REDLAND RIDGE SUBDIVISION PRELIMINARY OVERALL AREA DEVELOPMENT PLAN

POADP # 608

The City Staff Development Review Committee has reviewed Redland Ridge Subdivision Preliminary Overall Area Development Plan # 608. Please find enclosed a signed copy for your files. Although your plan was accepted, please note the following:

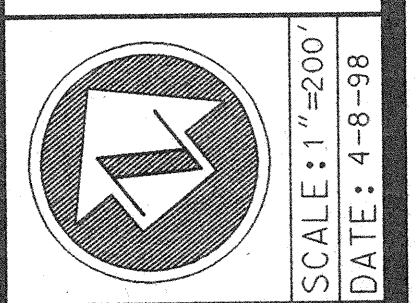
- I) The proposed street alignment of Gold Canyon Dr. as per major thoroughfare plan, has been added.
- ii) Location of driveway curb cut locations on divided roadway and 60 foot right of way (local type 'B') roadways. The location of the driveway curb cut locations will be determined when a final lot design for the subdivision is completed.
- iii) Secondary Entrance. A second entry into the subdivision, can be achieved by accessing proposed Gold Canyon Dr. A second entry via Redland Road is prohibited by the location of a sink hole within the area identified as an open space.
- iv) A traffic impact study will submitted to Traffic Dept. for their review.

- Called 5.21.98 El.
- ~~Gold Canyon 86' (label)~~
 - ~~TIA ok.~~
 - ~~Show "Collector
(I.D.) Streets"~~
 - no residential lots
on a ~~collector~~ collector
 - info on letter needs to
be reflected on
map.
